**COSMEC INC./DYNAMIC RUBBER**  
**REQUEST FOR INFORMATION (RFI)**

Job No.: 12341  
 Customer: A. L. ST. ONGE Contractor Inc  
 Project: ENOSBURG  
 Location: Boston Post Road T.H. 2- Franklin County

From: COSMEC INC.  
 RFI #: #001

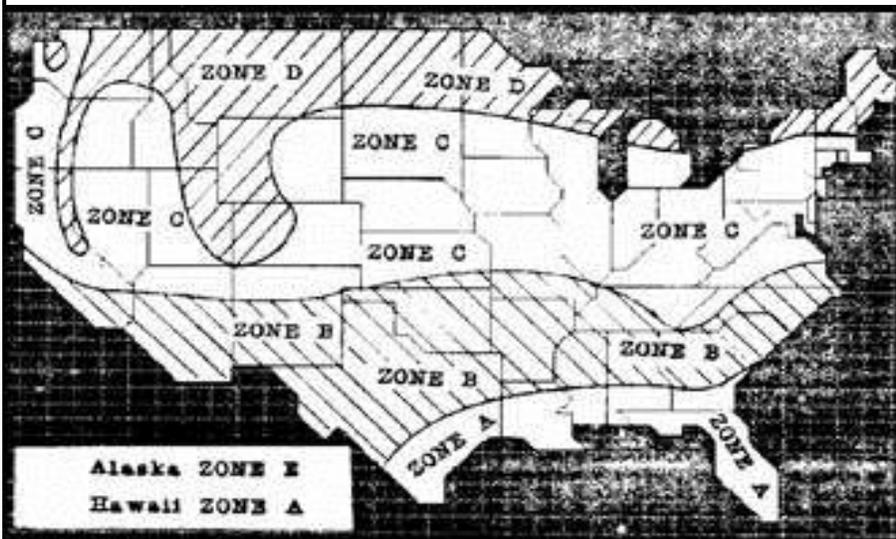
According to VT DOT spec 731.03 The elastomeric material can be Grade 4 Natural rubber or Grade 4 Neoprene.

The contract plans specified "Neoprene".

Typically neoprene will fall into the Grade 2 or Grade 3 category, Not Grade 4.

We produced these bearings with " Neoprene" as per the contract plans. The material used as Grade 3.

AASHTO LRFD GRADE ZONE MAP indicates this project location can be GRADE 3 as minimum.

Can we test and certify these bearings pads to Neoprene Grade 3 ?
